EPC PACKAGE FOR LARA SUPER THERMAL POWER PROJECT, STAGE-II (2x800 MW)
Amendment No. 05 to Technical Specifications Section-VI of Bidding Document No.: CS-9587-001R-2

Doc. No.: CS-9587-001R-2-TECH AMDT- 05	LARA SUPER THERMAL POWER PROJECT STAGE-II (2X800 MW)	Amendment No. 05 to Technical Specifications Section-VI
---	---	--

EPC PACKAGE FOR LARA SUPER THERMAL POWER PROJECT, STAGE-II (2x800 MW)
Amendment No. 06 to Technical Specifications Section-VI of Bidding Document No.: CS-9587-001R-2

EPC Package for Lara Super Thermal Power Project, Stage II (2 X 800 MW)
Amendment No. 7 to Technical specification Section VI of Bidding Document No.: CS-9587-001R-2

एन टी सी NTPC		NTPC Limited (A GOVT. OF INDIA ENTERPRISE) ENGINEERING DIVISION	
PROJECT		LARA SUPER THERMAL POWER PROJECT STAGE-II (2 X 800MW)	
TITLE		SCHEME OF CIRCULATING WATER SYSTEM	
SIZE	SCALE	DRG.NO.	REV.
A1	---	9587-999-POM-A-059	B

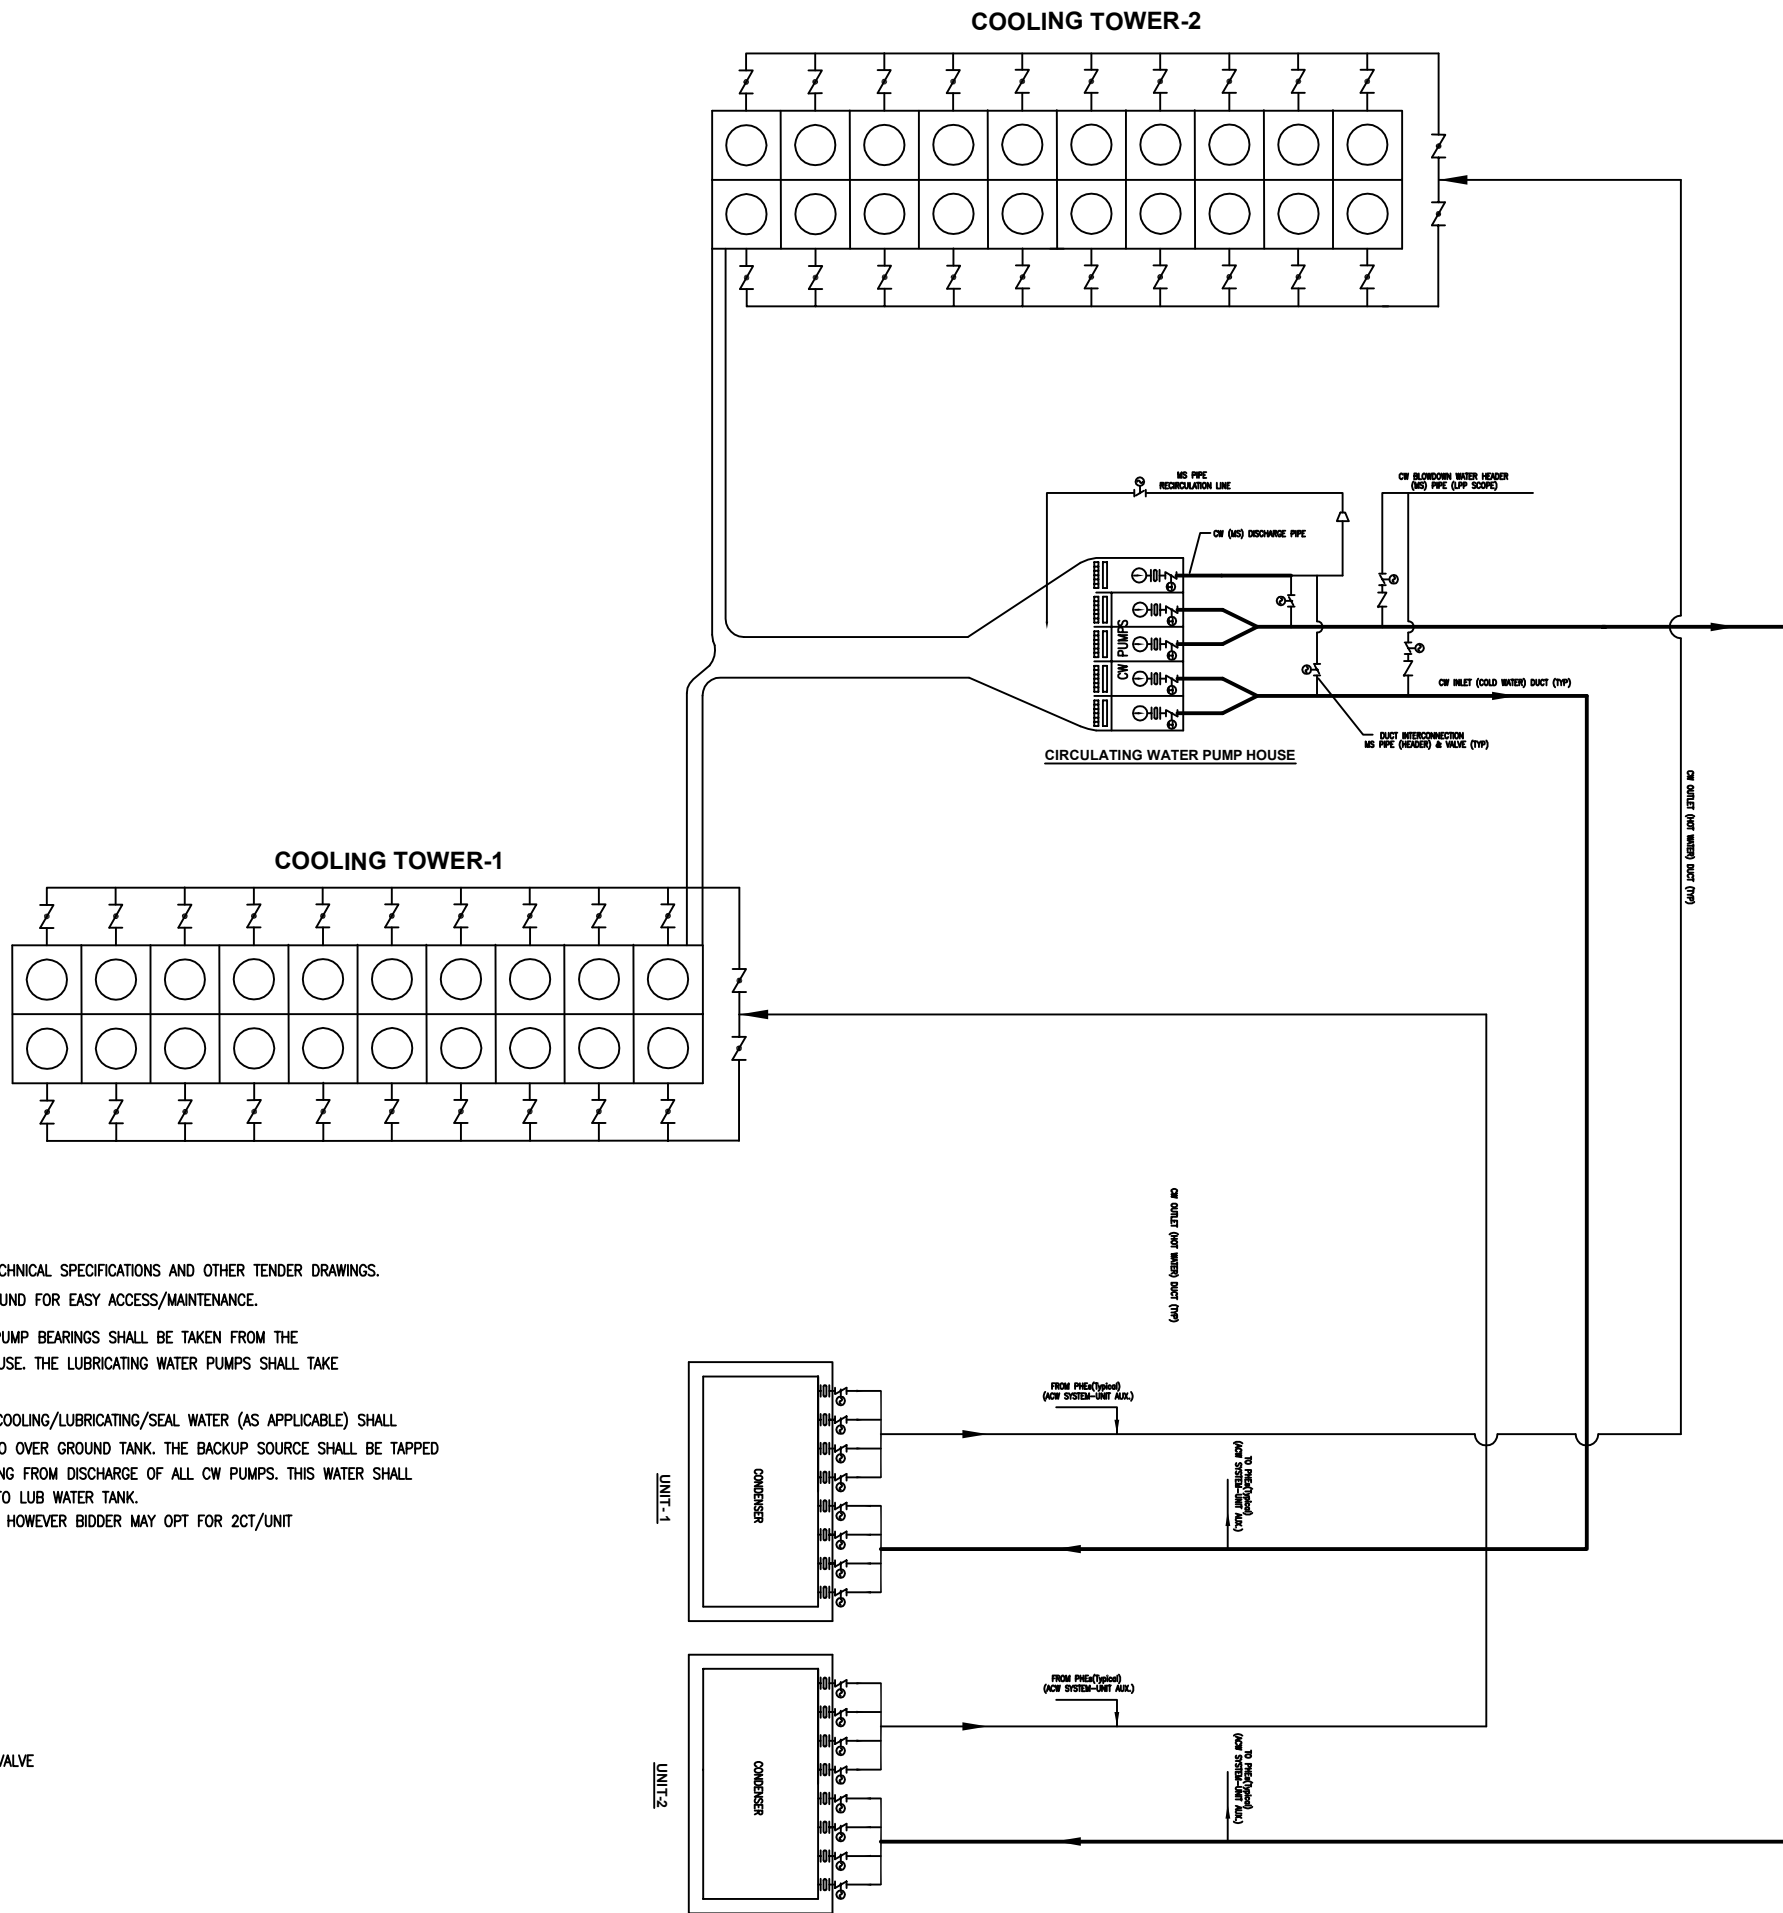
WS4-04	VI/B	A-01	3.02.00 a)	57 OF 101	Number of Cooling Towers: Two (2) numbers (One Number / Unit)	Number of Cooling Towers: Two (2) numbers (One Number / Unit) or Four (4) numbers (Two Numbers / Unit) as per configuration
WS4-05	VI/E	-	-	-	Tender Drawing “Scheme of Circulating Water System Rev A”	Tender drawing replaced with revised “Scheme of Circulating Water System Rev B”

1. THIS DRG. SHOULD BE READ IN CONJUNCTION WITH TECHNICAL SPECIFICATIONS AND OTHER TENDER DRAWINGS.
2. ALL THE VALVES SHALL PREFERABLY BE LAID OVERGROUND FOR EASY ACCESS/MAINTENANCE.
3. THE LUBRICATING / SEAL WATER REQUIRED FOR THE PUMP BEARINGS SHALL BE TAKEN FROM THE STORAGE TANKS TO BE PROVIDED NEAR THE PUMP HOUSE. THE LUBRICATING WATER PUMPS SHALL TAKE SUCTION FROM OVERGROUND STORAGE TANK.
4. DURING INITIAL FILLING AND NORMAL OPERATION, THE COOLING/LUBRICATING/SEAL WATER (AS APPLICABLE) SHALL BE TAPPED FROM NEAREST WATER SOURCE AND FED TO OVER GROUND TANK. THE BACKUP SOURCE SHALL BE TAPPED FROM A COMMON HEADER FORMED BY TAKING A TAPPING FROM DISCHARGE OF ALL CW PUMPS. THIS WATER SHALL PASS THROUGH 2 X 100% DUPLEX FILTERS AND FED TO LUB WATER TANK.
5. THIS DRG IS INDICATIVE FOR 1CT/UNIT CONFIGURATION, HOWEVER BIDDER MAY OPT FOR 2CT/UNIT CONFIGURATION AS SPECIFIED ELSEWHERE.
